[Reference: QIL-150P-02]

[URGENT: FIELD SAFETY NOTICE / FIELD SAFETY CORRECTIVE ACTION]

Regarding: Cystoscopy Bridges and Working Inserts - detaching fragments of adhesive

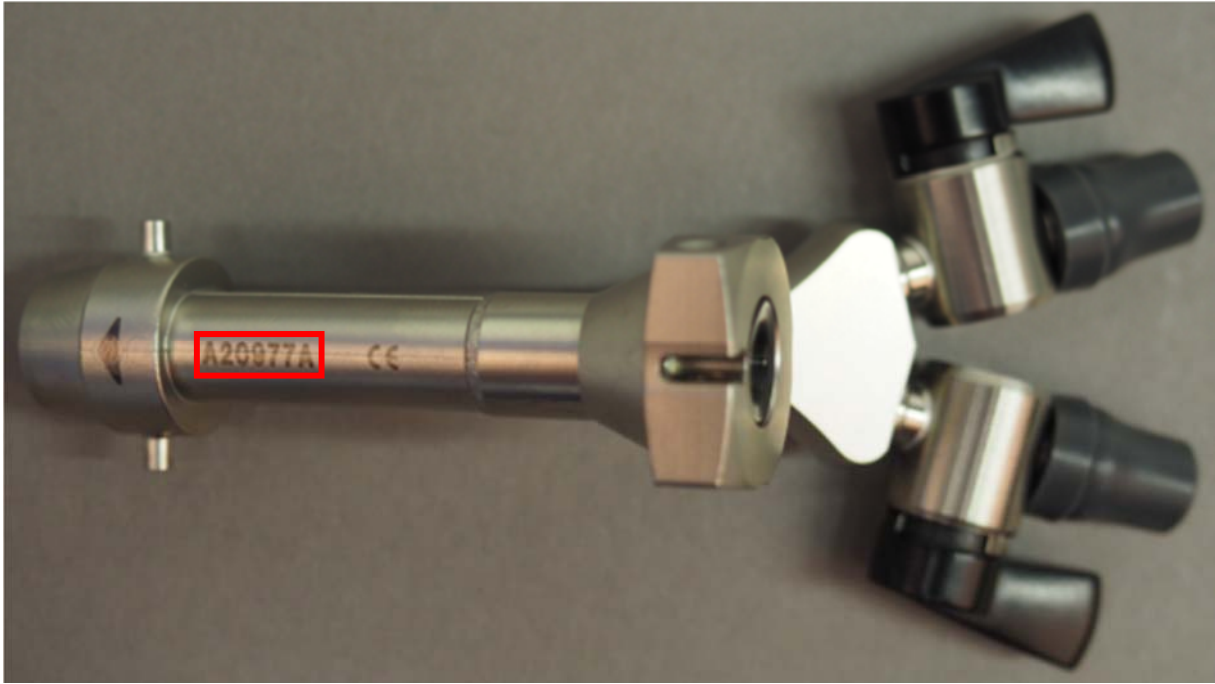
OLYMPUS has initiated this [FSCA / medical device corrective action] after receiving complaints about fragments of adhesive which detached from inside the working channel of the referenced cystoscopy bridge models. Cracking, chipping, missing pieces, and delamination of the adhesive have been observed. Investigations have confirmed that this adhesive can detach during the intended use of the cystoscopy bridge or working insert, e.g. when inserting an instrument through the working channel. As a result, a fragment of the adhesive may fall inside the patient's bladder or urethra and will need to be retrieved. Although typically flushed out with irrigation fluid or passed naturally, the retrieval of large fragments of the adhesive could require additional surgical treatment. Furthermore, the procedure can be prolonged resulting in extended anesthesia.

There has been no report about an adverse event or patient injury related to this issue. However, in an effort to prevent a potential risk to patient health, OLYMPUS is launching this action to provide its customers cystoscopy bridges and working inserts without adhesive. To achieve this, OLYMPUS will either rework the devices to remove the adhesive from the working channel or replace the devices completely. Please note that the lack of adhesive does not affect instrument passage.
